Appl. No. 10/698,314 Amdt. Dated May 25, 2005 Reply to Office Action of February 25, 2005

AMENDMENTS TO THE DRAWINGS

First Named Inventor: TAMADA, Teruo – TITLE: IMPACT ABSORBING MEMBER FOR VEHICLE – tty. Dkt # KYFS-US – Customer # 24222

Fig 33 Prior Art

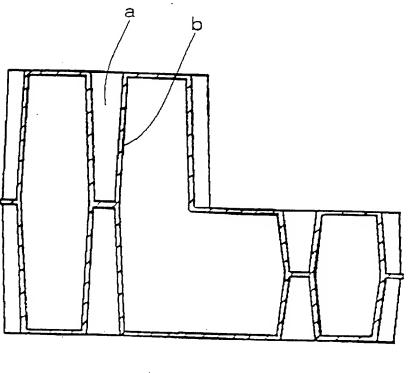
The applicant submits the required amendment to Figure 33. Claim 23 has been canceled. The applicant respectfully submits that this either cures or renders moot the Office's Objections to the Drawings.

The attached sheet of drawings includes changes to Fig. 33. This sheet, which includes Fig. 33, replaces the original sheet including Fig. 33. In Fig. 33, previously omitted legend "Prior Art" has been added.
